Cora Round Multi-function Shower Set

Old Version

New Version

PHC4502R

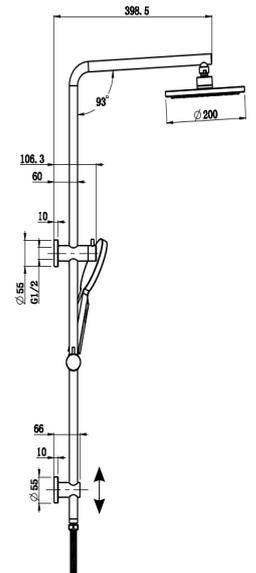
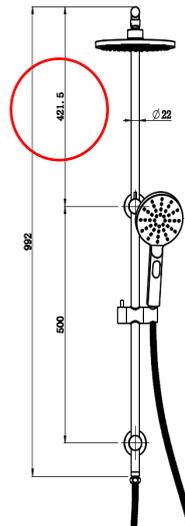
Old Model
Water inlet on the top

New Model - Universal Divertor
Water inlet can be top or bottom

The distance from the diverter inlet to the shower head elbow has increased from 342.5mm to 421.50mm

PHC4502RN
